PLANNING DEPARTMENT REPORT

YARMOUTH, MAINE

Minor Site Plan

Accessory Dwelling Unit, 166 East Elm Street

Site Plan for 166 East Elm Street

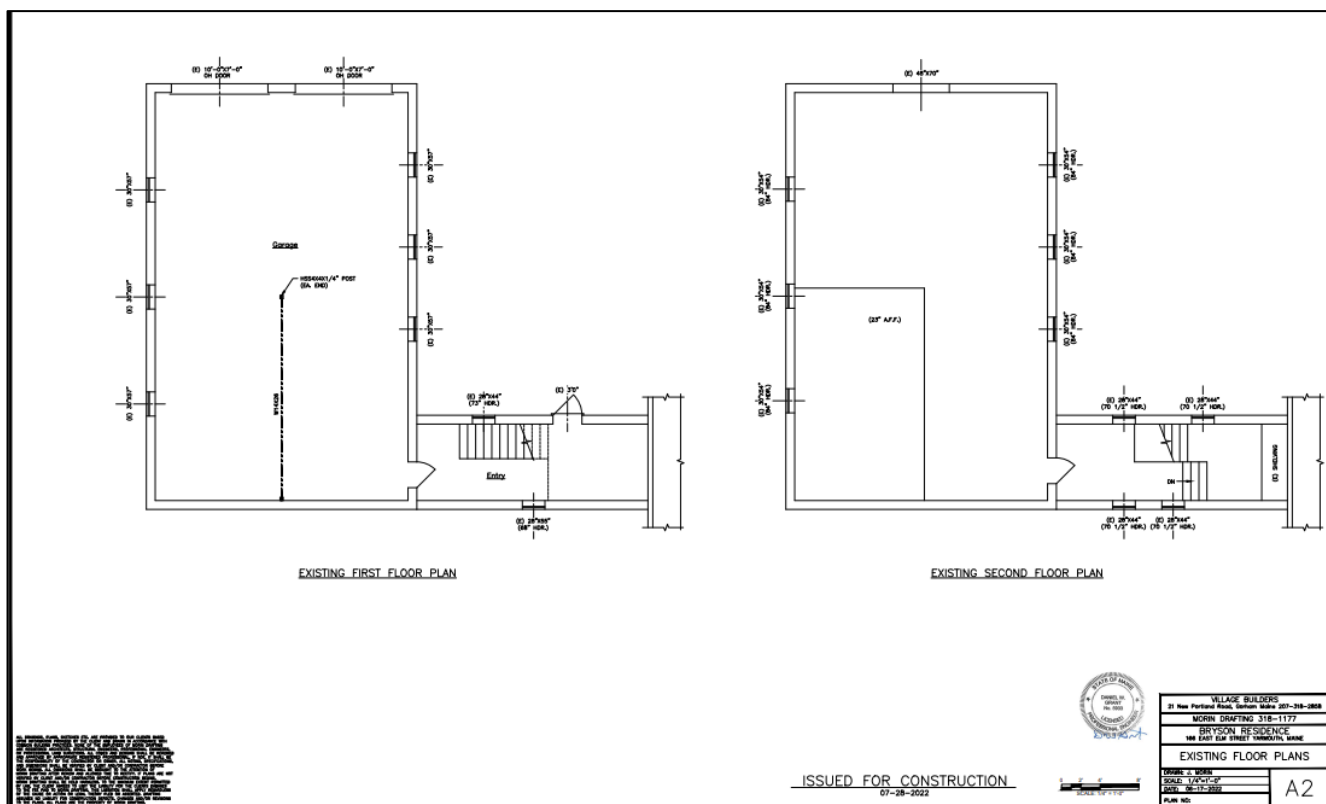
Town Comments: The applicant has provided a site plan dating from 2007, which was submitted when the garage was initially proposed as a new structure on the lot. The site plan shows items a – f, and the applicant will note on the drawing where the proposal is located. The applicant has provided additional construction drawings that show items h – K.

Existing Floor Plans

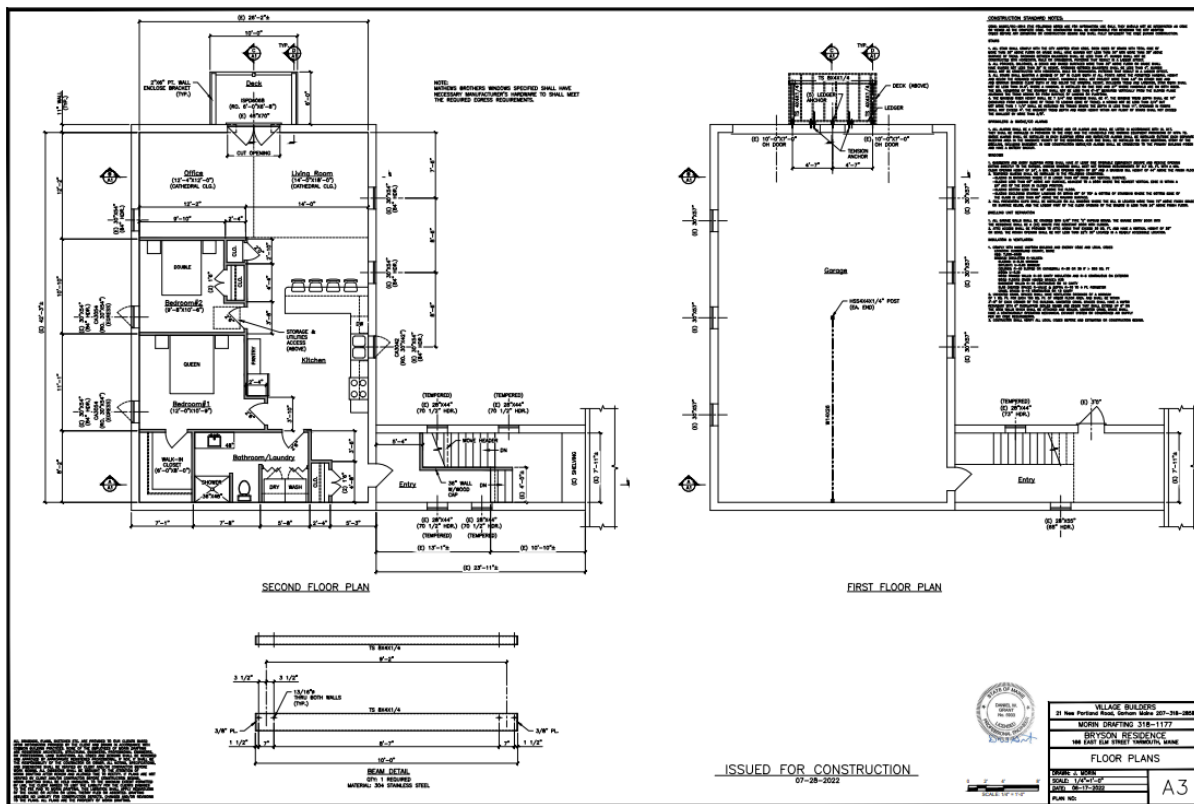
Town Comments: The applicant has indicated that the floor area of the unit is greater than 900 square feet, though this is due to the ADU occupying the entire second floor of the garage. The applicant has listed the footprint of the proposed unit as 1,232 square feet. Town Staff calculated the square footage at 1,105 square feet based on the measurements provided in the floor plan. The difference is likely due to the inclusion on the entry, which is not typically counted toward living area. Livable area does not include closets, stairwells, shafts, or other non-habitable spaces. In spaces with sloped ceilings, habitable space should only be calculated for the area having a ceiling height of five feet or greater in accordance with industry standards including 2015 International Residential Code (IRC)/ R304.3 *Height effect on room area*. It is likely that the ADU is even less than 1,105 square feet if the closets are removed from the living area calculation.

Although the ADU is greater than 900 square feet it, this standard allows the Planning Department to allow an increase in the allowed size of the ADU to efficiently use all of the floor area. All other standards of the section are met, so the Planning Department has determined that the size of the ADU meets the intention of the standard.
